Residue Upgradation Facility (RUF) EPCC-3 Package for Visakh Refinery Modernization Project (VRMP)	 L&T Hydrocarbon Engineering
		L&T-CHIYODA LIMITED
Title: Process Datasheet for AMINE BLOWDOWN DRUM (504-V-804) Doc. No.: B016-RUF-LT-504-PC-DS-0285		Rev. No.: 0 Page No: 1 of 2

ANNEXURE – 1**CHANGE LIST**

General: This document is based on Licensor datasheet for AMINE BLOWDOWN DRUM (504-V-804) issued with bid. Document is further updated based detail engineering requirements (refer Change List below for details).

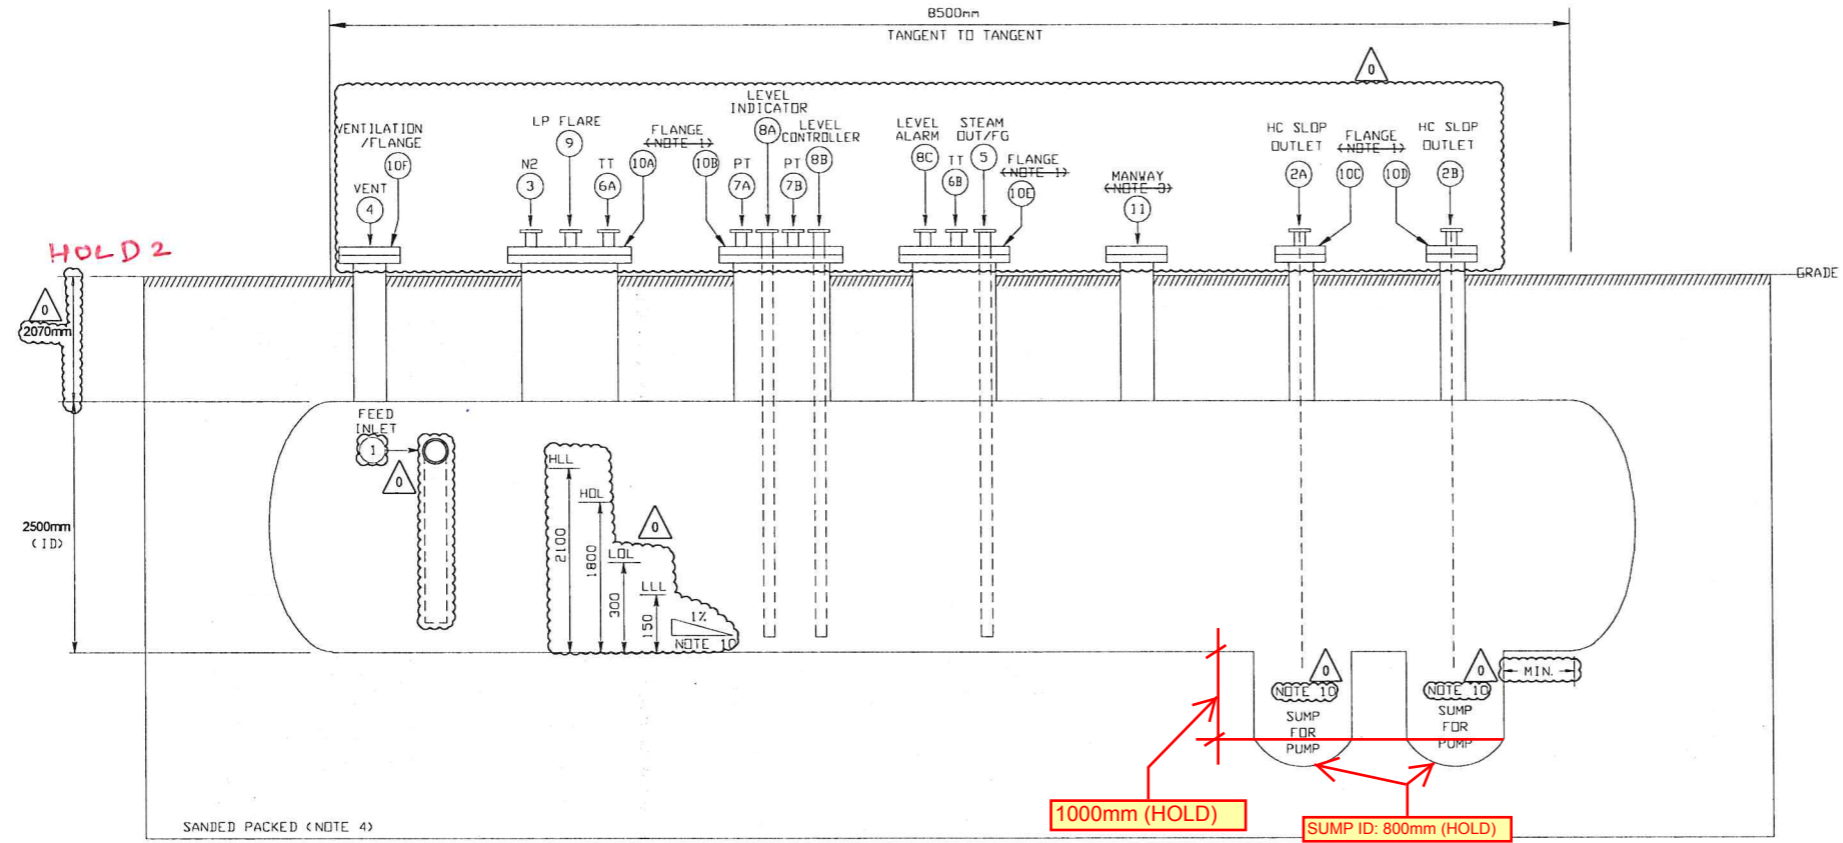
Sr. No.	Page No.	Description of change	Reference / Remarks
1.	2	Flanges numbers revised and sizes are defined in nozzle details & corresponding Note 1 is updated.	As per flange design input by Mechanical department. For detail refer mechanical engineering drawing. Number of flanges and detail will be updated in Rev 1 of P&ID: B016-RUF-LT-PID-504-11813.

2.	2	Vent (#4) & steam out nozzles (#5) sizes are confirmed as 2" each as vessel is non-cladded, in nozzle details & corresponding Note 2 is updated.	As per EIL guidelines in BEDB (Part-B) clause 8.5.3.3 doc. no.: A758-999-02-41-ODB-1001 pg. 73 of 115.

3.	2	Manway nozzle (#11) size (24") and location is confirmed and Note 3 deleted accordingly.	1. Location is at top shell of horizontal vessel. Final location will be decided by Mechanical engineering based on piping. There is no other Process engineering input required. 2. Manway size is defined based on EIL BEDB (Part-B) clause 8.5.3.3 A758-999-02-41-ODB-1001 pg. 73 of 115.

4.	2	Drum location w.r.t ground level is defined on vessel sketch and corresponding Note 4 is modified.	Relative elevation of drum is provided as per piping input considering slope of feed inlet blow down header to the vessel.

Sr. No.	Page No.	Description of change	Reference / Remarks
5.	2	Nozzle numbering is added to nozzle details and on vessel sketch.	For better clarity on nozzle identification.

6.	2	Feed nozzle (#1) update the location.	The feed nozzle was fouling with knuckle of vessels while placing it above HLL. Hence, the feed nozzle was shifted to shell as marked based on input by Mechanical department.

7.	2	Ventilation/Vent nozzle (#10F) updated to Ventilation/Flange nozzle and Vent nozzle #4 defined separately.	As per mechanical department input, Ventilation nozzle is considered as flange. For further details, please refer Mechanical Engineering Drawing.

8.	2	Level tap nozzle #8 (A-C) size is defined as 4" in nozzle details.	As per Instrument design basis & EIL guidelines in doc. no. B016-504-16-EDB-95097-52-0001.

9.	2	Liquid level nomenclature is modified on vessel sketch for better clarity on level identification.	As per EIL guidelines in BEDB (Part-B) Abbreviations on pg. 11 of 115 A758-999-02-41-ODB-1001.

10.	2	High Liquid Level (HLL) is revised from 2200mm to 2100mm. Low liquid level (LLL) is defined as 150 mm.	To place the Feed nozzle above HLL, the HLL was reduced. The total pumpable volume between HLL and LLL is ensured as 40 m ³ as specified in EIL BEDB (Part-B) clause 6.8.2 pg. 44 of 115 A758-999-02-41-ODB-1001. For detail calculations, please refer Annexure 2.

11.	2	Slope is defined as 1% inside vessel and corresponding Note 10 is added.	To drain towards sumps as per good engineering practice. It will be updated in Rev 1 of P&ID: B016-RUF-LT-PID-504-11813.

12.	2	Sump and pump discharge nozzle location is changed in vessel sketch and corresponding Note 10 is added.	Location of sumps is towards sloping end of vessel and minimum from TL. Location is changed in order to ensure complete draining of vessel due to slope.

13.	2	Sanded Packed Note 3 changed to Note 4 in vessel sketch.	To provide correct reference of Note 4.

Sr. No.	Page No.	Description of change	Reference / Remarks
14.	2	Trim added as Note 8.	As per PMS of inlet and outlet lines indicated in P&ID : B016-RUF-LT-PID-504-11813 Rev 0.
15.	2	MDMT of 12.5 °C added in Note 9.	As per EIL guidelines in BEDB (Part-B) clause 4.2 pg. 22 of 115 A758-999-02-41-ODB-1001.
